SERVICE BULLETIN

APL-SB22

Date of Issue: 06 Oct 2023

SUBJECT: FAULHABER PITCH CHANGE MOTOR REVISION 5 BRUSH-HEAD UPGRADE

Figure 1. Modifications to upgraded Faulhaber brush-head revision 5.

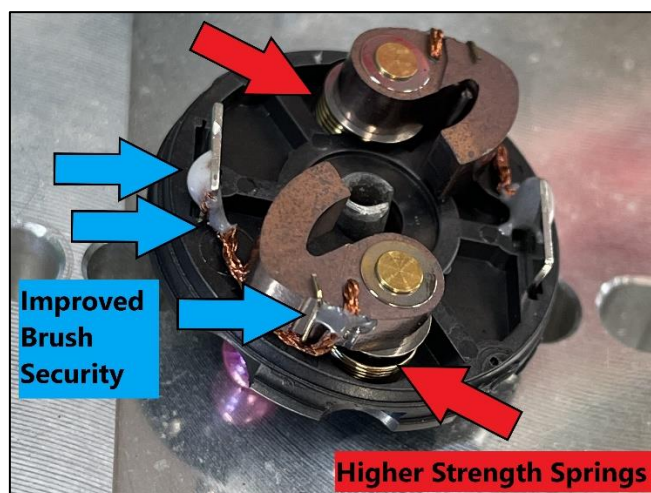
1. The commutator brushes and springs contained within Revision 1 or 2 Faulhaber pitch change motors (A0457-196) have exhibited the following characteristics in some situations:
 - a. The braided copper leads to the brushes may fail in service after a period of time on some engine types due to the high vibration environment. This leads to a failure of the pitch change motor, as indicated by all three LEDs flashing red (1Hz) on the AC200 controller (open circuit alarm) and a loss of pitch control.

2. A modified brush-head assembly has been developed for Faulhaber pitch change motors. This upgrade improves the security of the brush leads and incorporates higher tension springs. The upgraded brush head may be retrofitted to existing Faulhaber pitch change motors.

3. Affected pitch change motors must be returned to Airmaster Propellers for this upgrade as it can't be completed in the field. This upgrade elevates the pitch change motor to a revision 5. The upgraded brush head assembly is implemented in all manufactured Faulhaber pitch change assemblies from revision 5 up.
